IOWA DEPARTMENT OF NATURAL RESOURCES ENGINEERING BUREAU WALLACE STATE OFFICE BUILDING

GEODE STATE PARK
RECONSTUCT BEACH/BOAT RAMP PARKING LOT
DES MOINES COUNTY, IOWA
PROJECT NO. 22-06-29-01

September 16, 2022

This Addendum is issued to modify, explain or correct the original Drawings and Specifications, and is hereby made a part of the Contract Documents. Please attach this Addendum to the Project Manual in your possession. Insert the number and issue date of this Addendum in the blank space provided on the Proposal Form.

C.01

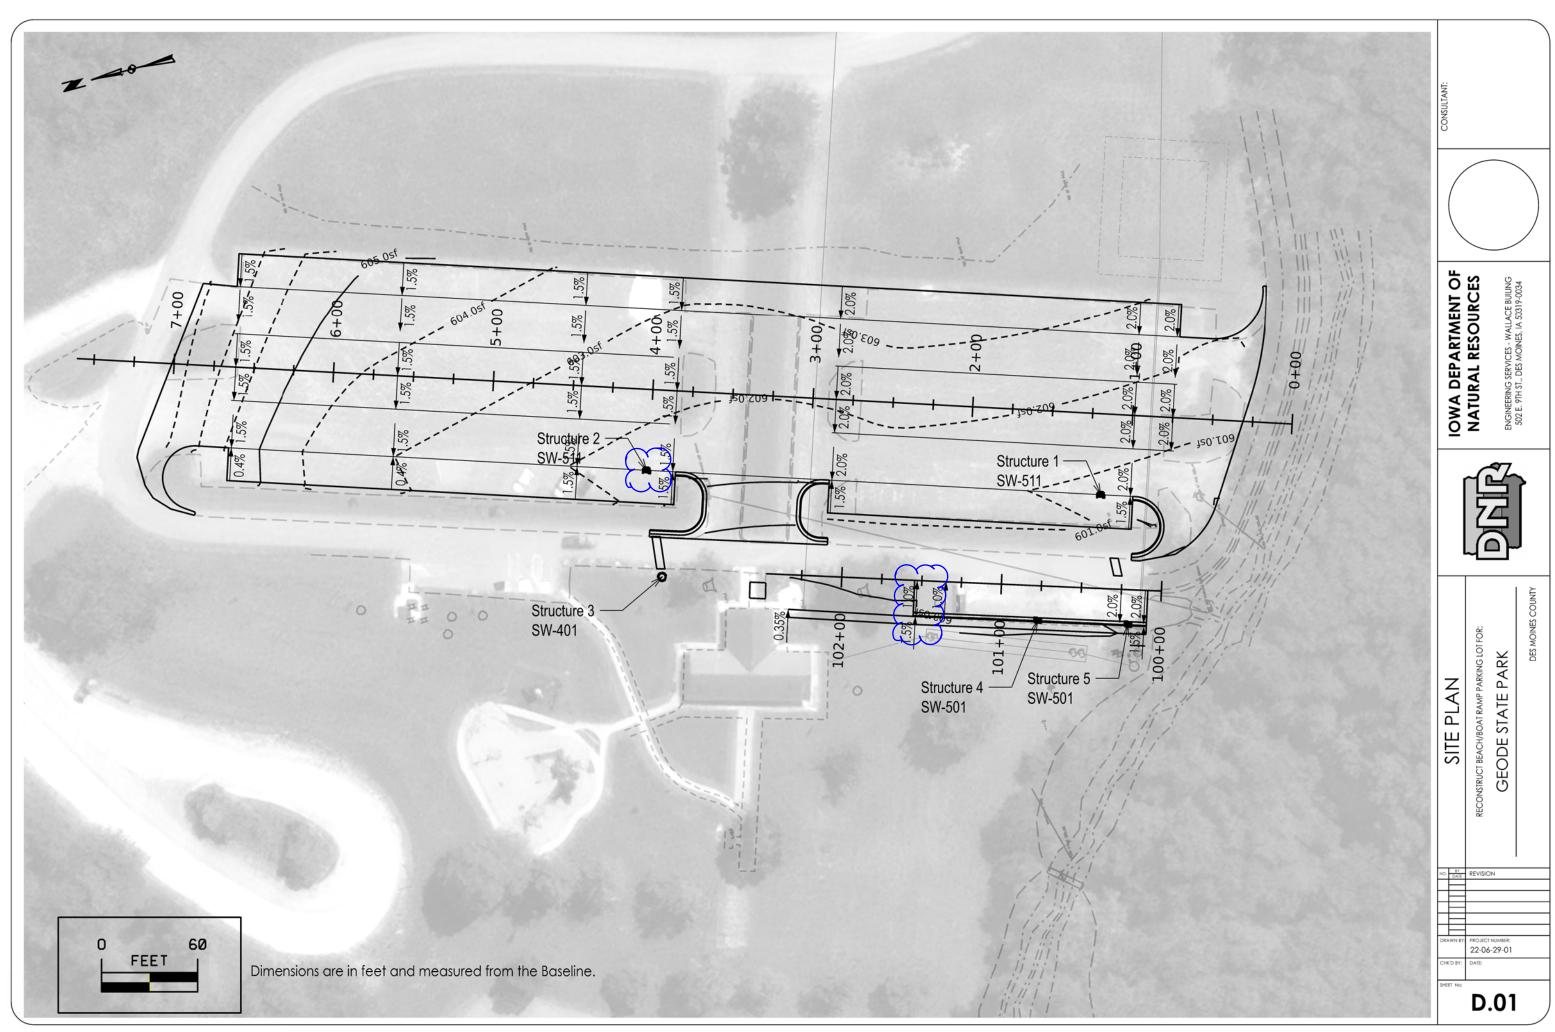
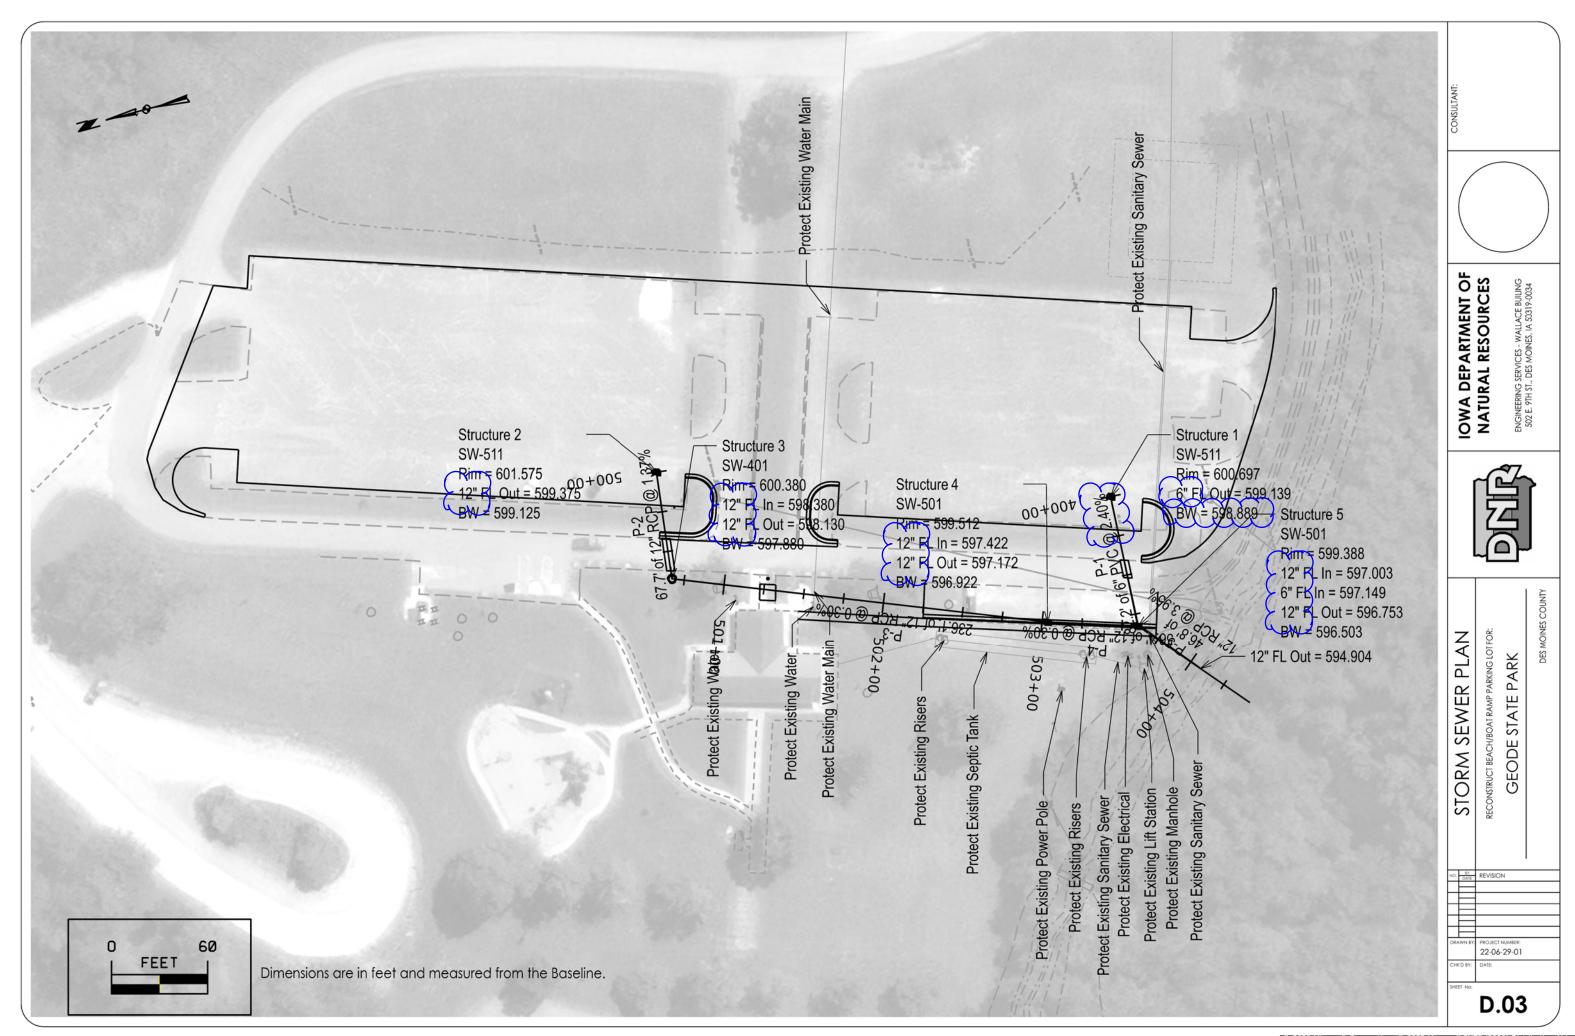
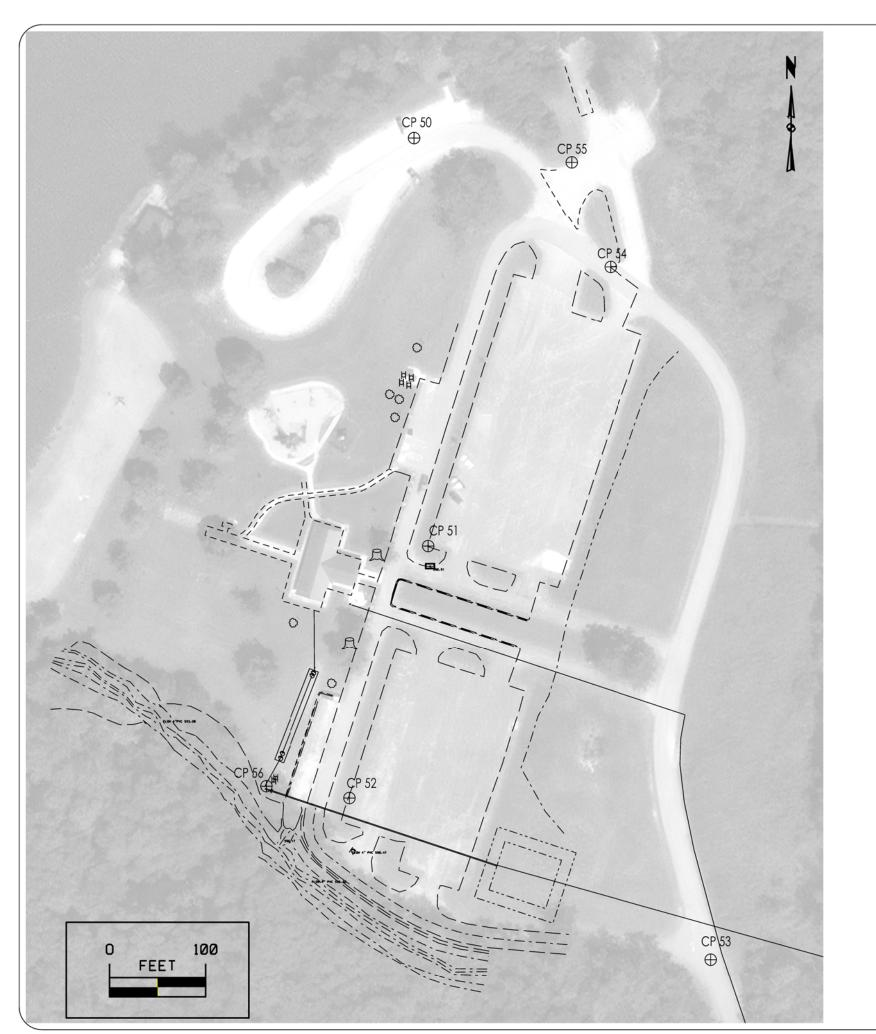
- A. C.01
 - a. The following bid item quantities have been updated.
 9 Pavement, 7" PCC 10,782 SY
 11 Special Backfill 1,907 CY
 12 Curb and Gutter, PCC, 2.5' 339 LF
 - b. The following note has been added to the Estimate Reference Information for bid item 11 Special Backfill "G. No measurement to be made. Plan quantity to be used unless the pavement area is increased or decreased from plan."
- **B.** D.01
 - a. Structure 2 location changed.
 - b. Small parking lot extended 2'.
- **C.** D.03
 - a. Pipe sized added to structure flowlines.
 - b. P-1 slope updated.
 - c. BW added to Structure 1
- **D.** G.01
 - a. Alignment tables for StrmSwr and StrmSwr2 updated.
- E. P.01
 - a. Car stalls added ands changed in the center parking rows.
 - b. Handicap aisles added.
